HISTORIC AND DESIGN REVIEW COMMISSION February 15, 2017

HDRC CASE NO: 2017-046 **ADDRESS:** 430 BURLESON ST **LEGAL DESCRIPTION:** NCB 520 (432 BURLESON), BLOCK 24 LOT 20 **ZONING:** IDZ **CITY COUNCIL DIST.:** 2 **DISTRICT: Dignowity Hill Historic District APPLICANT:** Juan Fernandez/CVF Homes **OWNER:** A&F Partners Amendment to a previously approved design regarding facade materials **TYPE OF WORK:**

The applicant is requesting a Certificate of Appropriateness for approval to amend a previously approved design in regards to facade materials. The applicant has proposed to install lap siding instead of the previously approved shingle siding.

PERSPECTIVE LOOKING SOUTHWEST

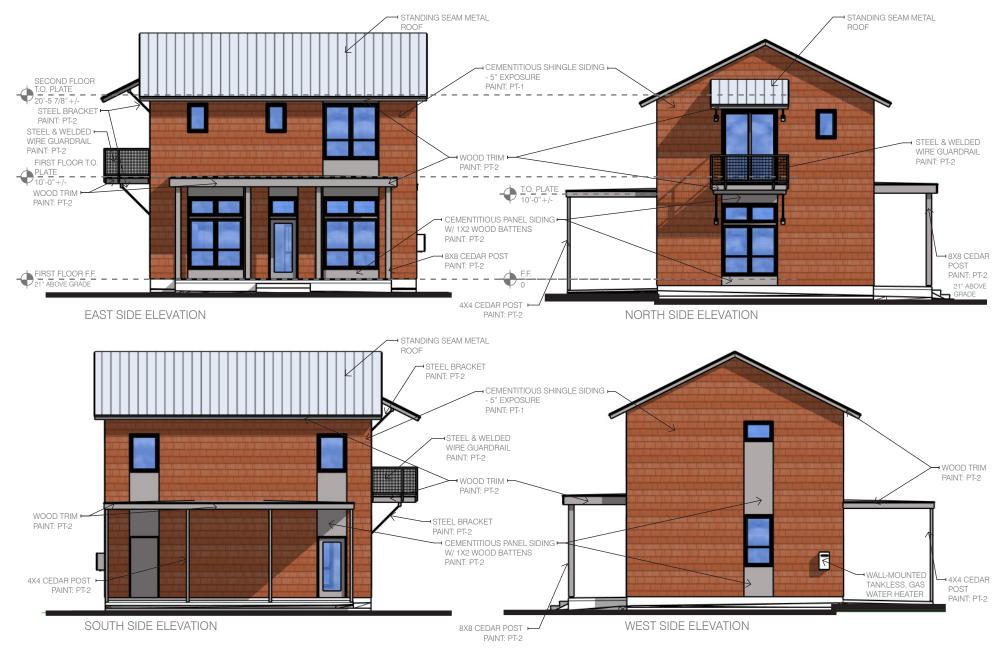
- a. The new construction located at 430 Burleson was approved at the September 7, 2017, Historic and Design Review Commission hearing. At that hearing, the façade material for 430 Burleson consisted of cement shingle siding with a 5" exposure. The proposed siding was to be painted "robust orange". At this time, the applicant has proposed to amend the previously approved design to include the installation of cement lap siding to feature either a 4" or 5" exposure.
- b. Per the Guidelines for New Construction 3.A.iv., Hardi Board or other fiberboard siding may be appropriate for new construction in some locations as long as new materials are visually similar to the traditional material in dimension, finish and texture. Staff recommends the applicant install the proposed siding with a 4" exposure and a smooth finish.

Previously approved facade material - cement shingle siding

Staff recommends approval based on findings a and b with the stipulation that the applicant install siding that features a 4" exposure and a smooth finish.
